SERVICE BULLETIN: JSB 037-1

Release Date: 20th March 2015

Subject: Wing attachment bolts

Affected Models: Jabiru Aircraft with over 2000 airframe hours

Figure 1 - AN4 wing attachment bolts - 2000 hour life

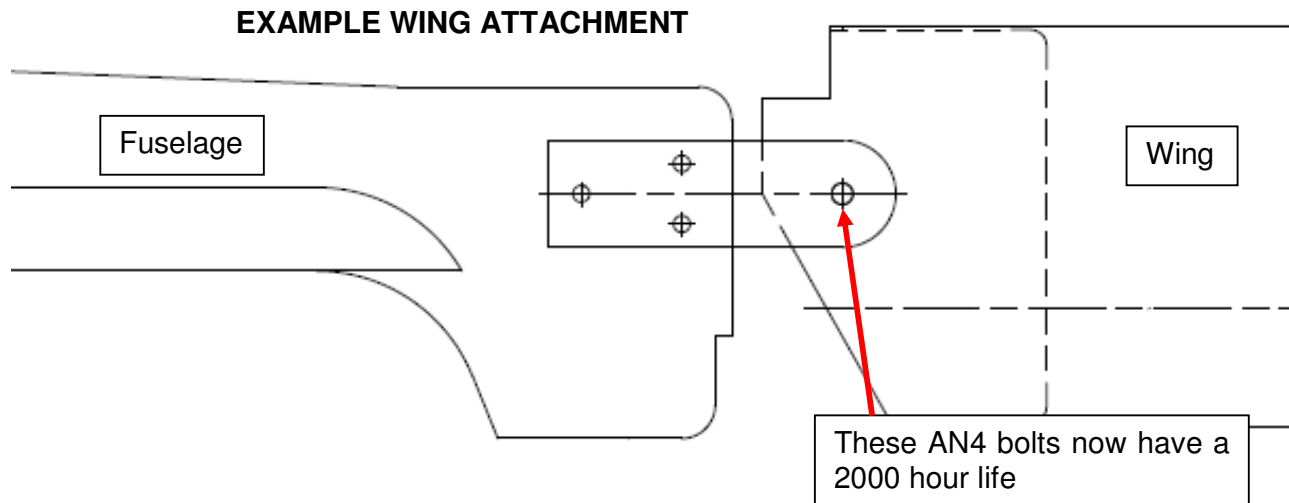
- All Jabiru Aircraft feature strut braced wings with the root of each wing attached to the fuselage through two bolted joints loaded in shear.
- At manufacture these joints are secured using AN4 bolts (i.e. 1/4 inch diameter)
- Examination of several airframes which have reached 5000 hours' time in service revealed one only original AN4 bolt that was not in acceptable condition. The bolt was never replaced during the 5000 hour period.
- As a precautionary measure a **2000 hour life** is now imposed on all AN4 wing attachment bolts, both the front and back. Figure 1 identifies this bolt.

- AN4 Bolts and nuts used in the position shown (both front and back attachments) in **Figure 1** must be replaced after 2000 hours' Time-in-Service (TIS).
- AN4 Bolts which have already surpassed 2000 hours TIS are to be replaced at the next 100-hourly or annual inspection conducted for the aircraft whichever occurs first.
- The Time-In-Service is measured using Hobbs time (not Tacho or Airswitch). Jabiru Service letter JSL010 provides details on service time interval requirements

- Prior to removing and replacing AN4 bolts, check if there is any free play in the connection by holding the end of the wing firmly with both hands and attempting to move it forward and aft. If free play is detected there are several procedures to correct this condition, however simply replacing the AN4 bolts with new ones will not always stop the free play movement. Contact Jabiru Aircraft for details.
- If free play is not detected the procedure for the removal and replacement of the wing may be used. This is provided in the Jabiru Airframe Technical Manual (JTM001-5 or later version). The old AN4 bolts, nuts and washers are replaced with new ones.
